**Historical Architectural Review Board  
COA Final Review Sheet**

**HDC-2023-00020**

**Address: 631 N. Park Street**

**Proposal: Replace metal porch posts and railings; legalize tile flooring, stucco, railings, and roofing**

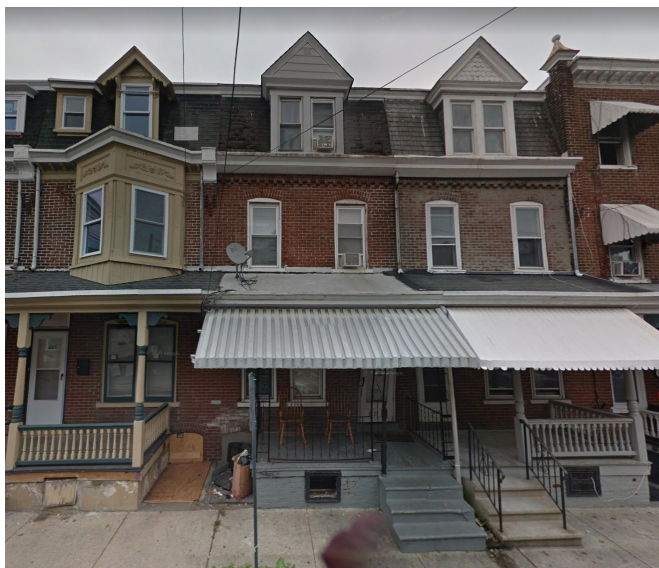
The applicant applied to staff to replace the existing metal porch railings and posts. After reviewing the application, staff learned that the work had already been completed and that the scope also included removing the awning, replacing the porch roof, installing railings at the steps, stuccoing the brick foundation wall, adding a new cover at the foundation opening, and tiling the wood porch and concrete steps.
